C. K. McCoy
Vice President, Nuclear
Vogtle Project

June 17, 1992

ELV-03718
001664

VOGTLE ELECTRIC GENERATING PLANT
REQUEST TO REVISE TECHNICAL SPECIFICATIONS
3/4.6.1.7 AND 4.6.1.2f

FIGURE 1

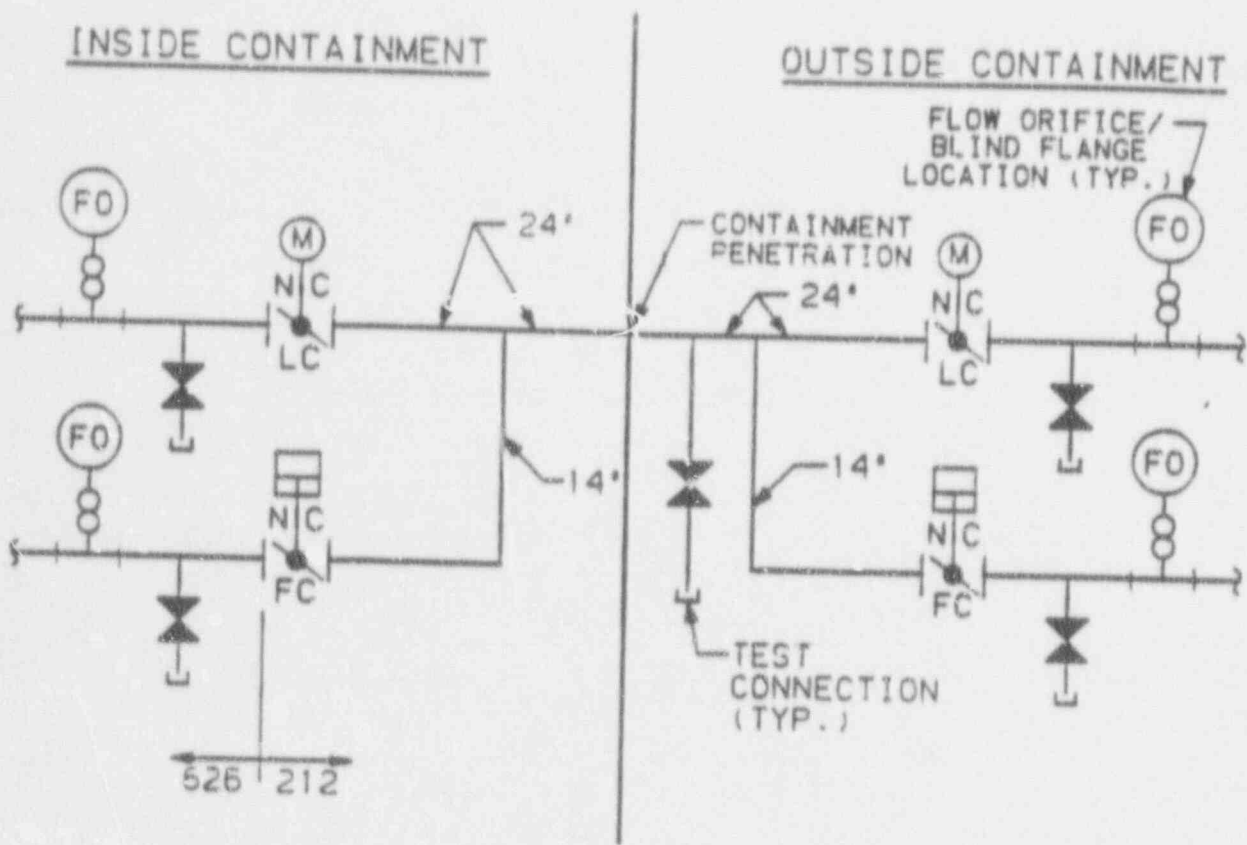
Section III.C. "Type C tests," of Appendix J, "Primary Reactor Containment Leakage Testing for Water-Cooled Power Reactors," to 10 CFR 50 states that for containment isolation valve local leak rate testing, "pressure shall be applied in the same direction as that when the valve would be required to perform its safety function, unless it can be determined that the results from the tests for a pressure applied in a different direction will provide equivalent or more conservative results." As a result of Information Notice No. 88-73, it is uncertain that the preferred method of testing at VEGP can be considered to provide equivalent or more conservative results with respect to the inboard containment purge supply and exhaust isolation valves. However, in order to test these valves by pressurizing in the accident direction, containment entry is required. Since these tests must be performed at quarterly intervals as required by existing surveillance requirement 4.6.1.7.2, the necessity of making a containment entry each time the test must be performed works a hardship on plant personnel, especially from the standpoint of maintaining personnel exposure as low as reasonably achievable (ALARA). Figure 1 illustrates the typical arrangement of valves, test connections, and blind flanges for purge supply and exhaust penetrations.

In addition, the proposed Technical Specification amendment would provide for an alternate means of isolating the purge penetrations in the event of excessive leakage through an isolation valve. Isolating the affected penetration via blind flanges will assure that containment leakage is maintained within limits while allowing for maintenance to be performed on the inoperable valve associated with the affected penetration. Furthermore, the revised action statements provide for a graded response depending on the severity of the leakage. In the event that excessive valve leakage causes the combined leakage to exceed 0.60 La (the leakage limit of Specification 3/4.6.1), the revised action statements are consistent with the provisions of LCO 3.6.1.1.
